ADDENDUM NO. 2 (AD-02)

RICHMOND REGIONAL JUVENILE DETENTION CENTER RENOVATION

SCO # 22-24596-02A

Date – 3/30/2023

WALL SECTION KEYNOTES

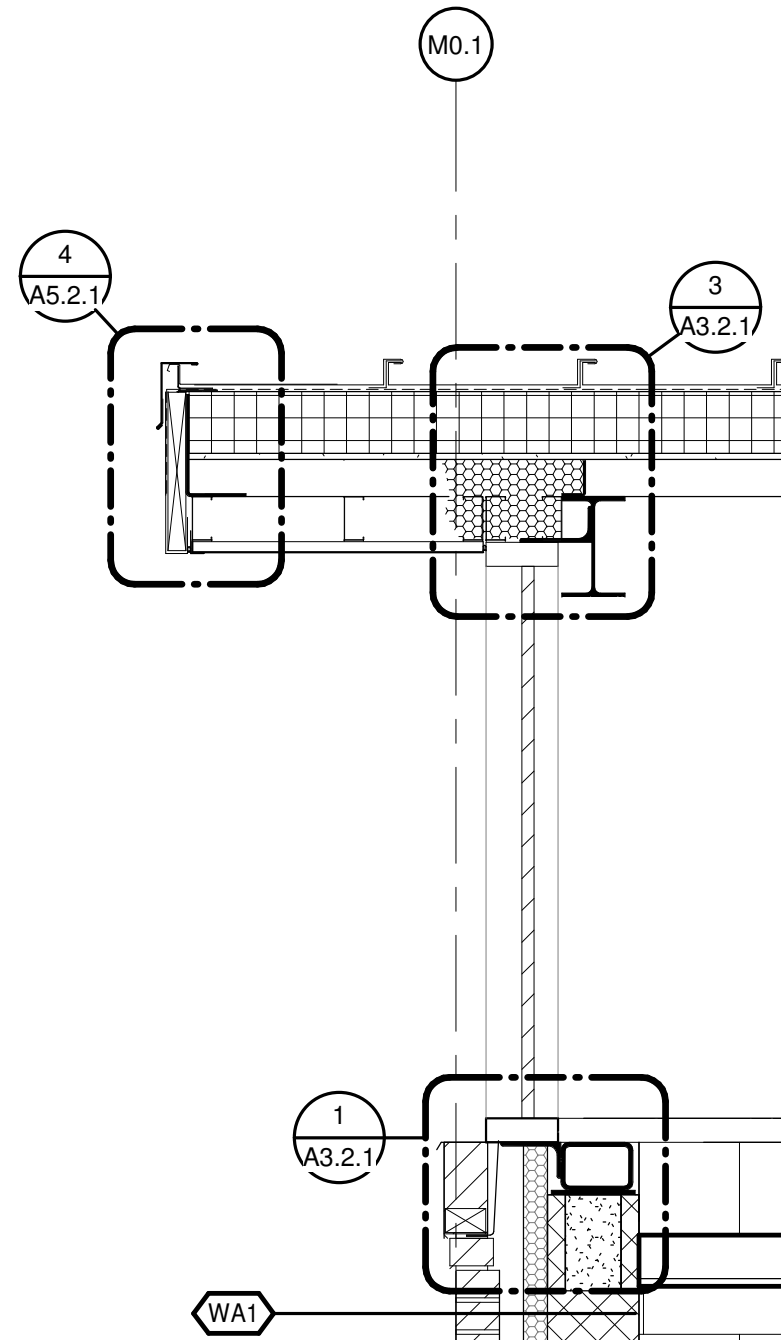
QUESTION: Question regarding the PEMB metal wall panels: Specifications 133419-11 call for a regular metal panel (non-insulated). Plans A0.2.0 (Wall Type WA3) call for an insulated metal wall panel. This is a conflict, which should we follow? According to wall type WA3, there is batten insulation sandwiched between two metal wall panels. Having an insulated metal wall panel on the outside will be likely be unnecessary and will greatly increase the cost of the PEMB.

ANSWER: Refer to revised Drawings attached.

MARK	FIRE RATING (REFER TO LS 1.1 FOR LEGEND)	REMARKS	INFORMATION
WA1 WA2			1'-3 1/4" @ WA1 1'-2 5/8" @ WA2 FACE BRICK AIR SPACE 2" SPRAYED POLYURETHANE FOAM AIR BARRIER 8" CMU
WA3			METAL LINER PANEL BATT INSULATION R-13 11" PEBB STEEL GIRT PEBB UNINSULATED METAL PANEL 3 5/8" METAL STUD @ 24" O.C. 5/8" IMPACT-RESISTANT GYP. BD.
